Direction Générale de l'Énergie et du Climat  
Sous-direction à la sécurité et aux émissions des véhicules

# **NEW RADIAL STRUCTURE DEFINITION PROPOSAL IN UN REG. 30**

**GRBP - 73TH SESSION – JANUARY 2021  
INFORMAL DOCUMENT LINKED TO INFORMAL DOCUMENT 72-24**

## Current radial definition

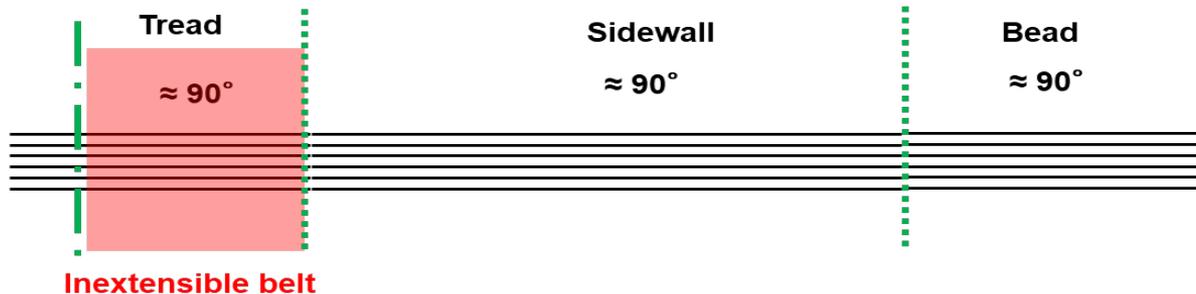
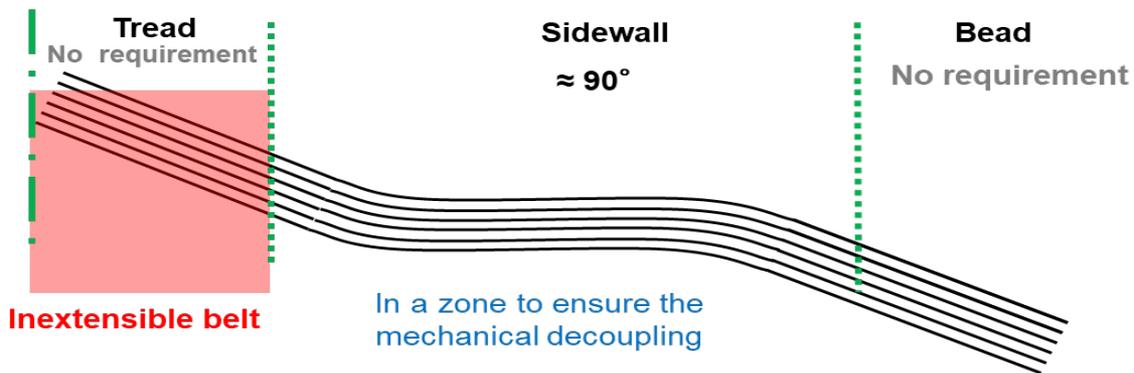
The mechanical decoupling is provided by the ply cords laid at substantially 90° in a zone between the bead and the inextensible circumferential belt.

"2.9.3. "Radial" or "radial-ply" describes tyre structure in which the ply cords extend to the beads and are laid substantially at 90° to the centre line of the tread, ~~the carcass being stabilized by an essentially inextensible circumferential belt in a~~ **zone including most of the side wall and [located] outside the bead and the essentially inextensible circumferential belt that stabilizes the carcass;"**

# 1) Can a bias tyre fall into the radial definition ? Same situation as today

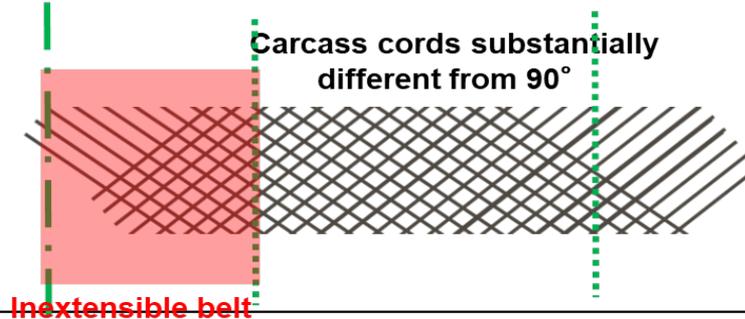
Def. Bias means « *ply cords laid at alternate angles substantially less than 90°* »

Complies with

- today's
- and
- proposed definition

Does not comply with

- today's
- nor
- proposed definition

## 2/ Can the proposed definition allow « less radial » tyres than today ?

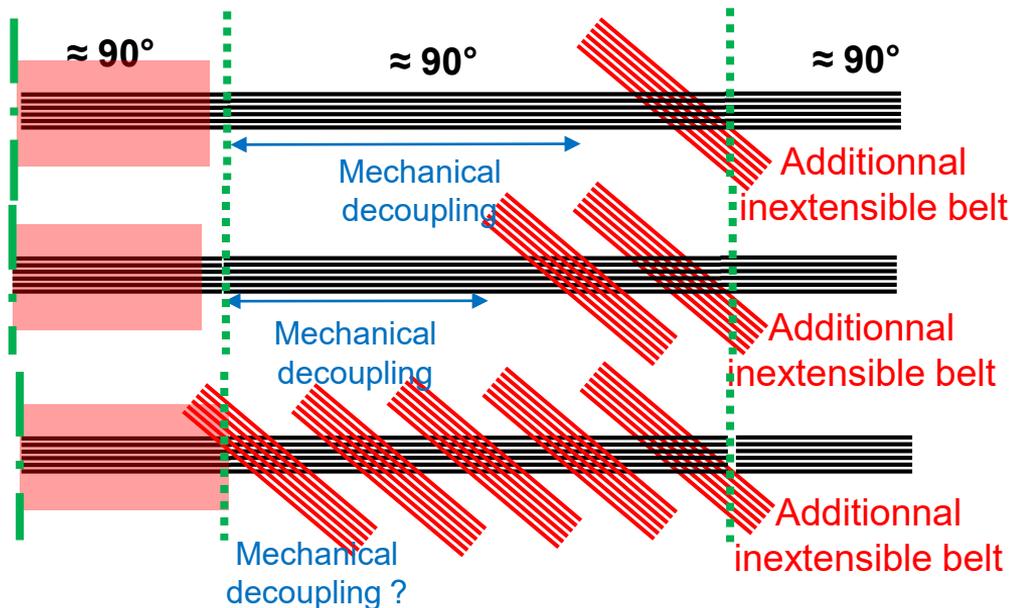
Current definition does not necessary guarantee a minimum mechanical decoupling between tread and bead zone.  
The proposed definition does not introduce additional risk on that point compared to today's definition.

Complies with  
both definitions

### 3/ Can the proposed definition increase the difference within a regulatory tyre type (axle mixability) ?

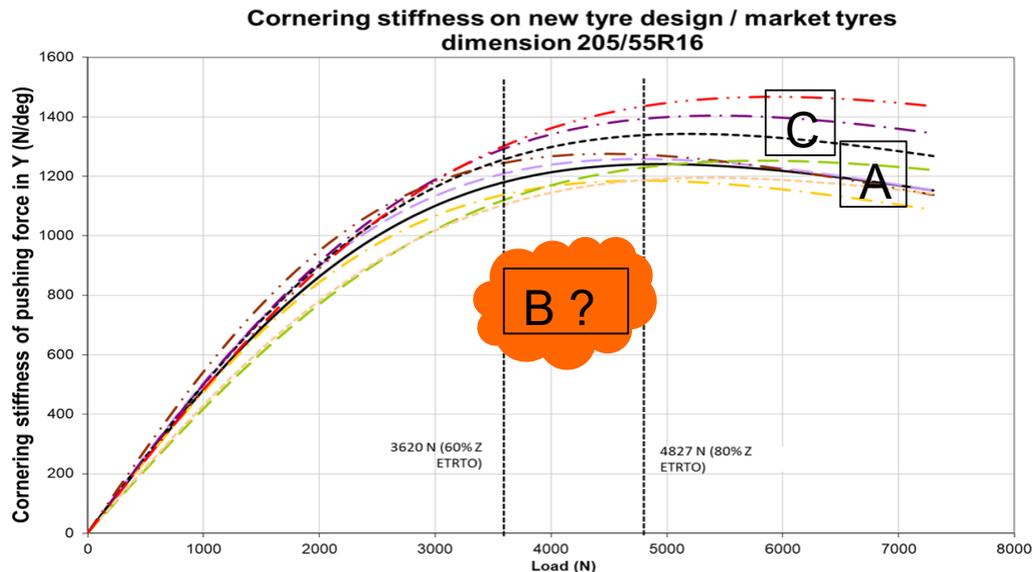
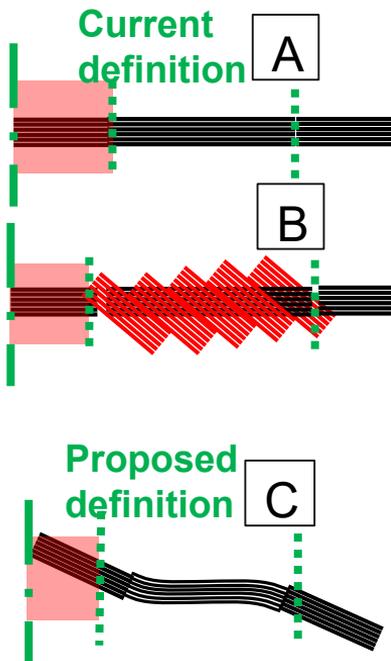
There can be more differences between A and B (radial tires complying with today's definition) than between A and C current vs. proposed definition).

### 3/ Can the proposed definition increase the difference within a regulatory tyre type (axle mixability) ?

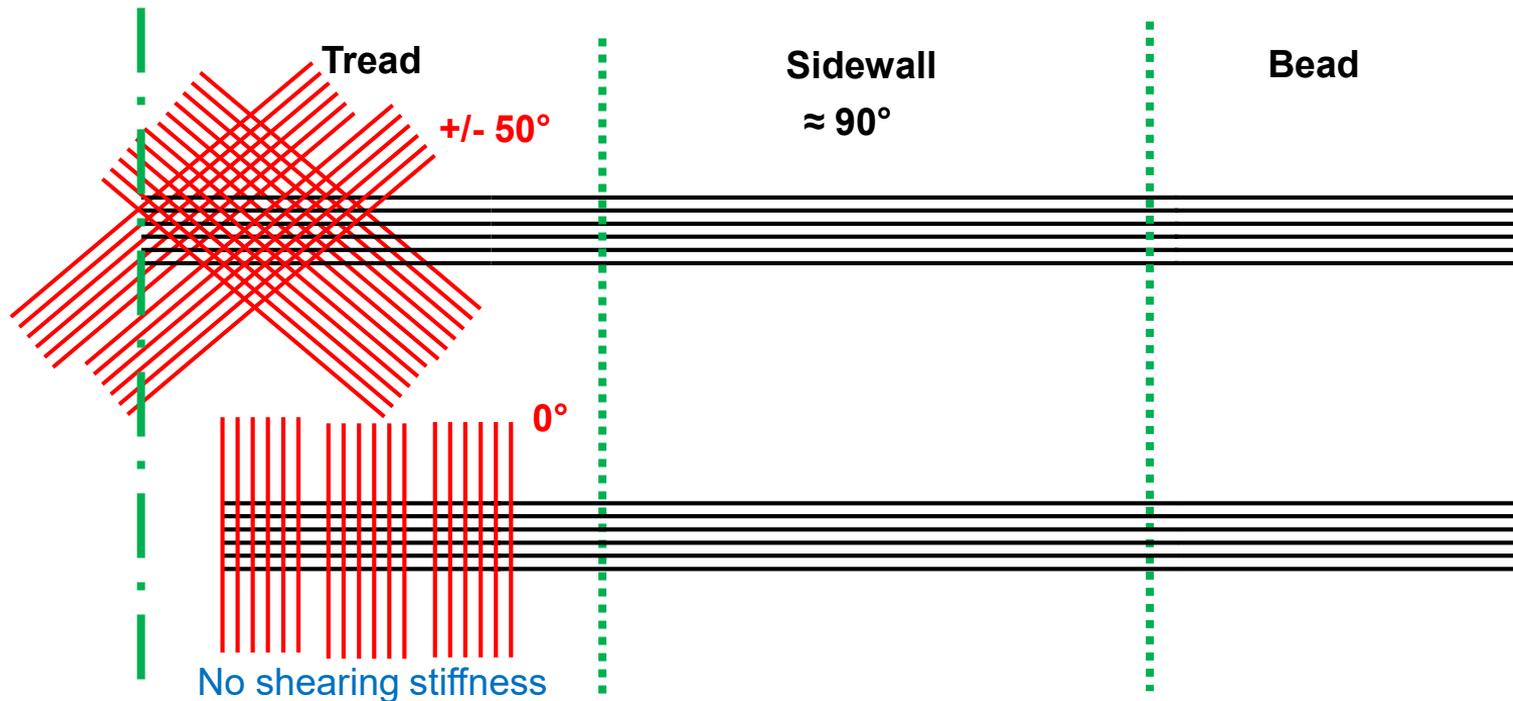
Both constructions comply with the radial definition (both current and proposed).

Radial definition alone does not guarantee axle or even vehicle mixability (in the end, this will be managed and ensured by the tyre manufacturer)
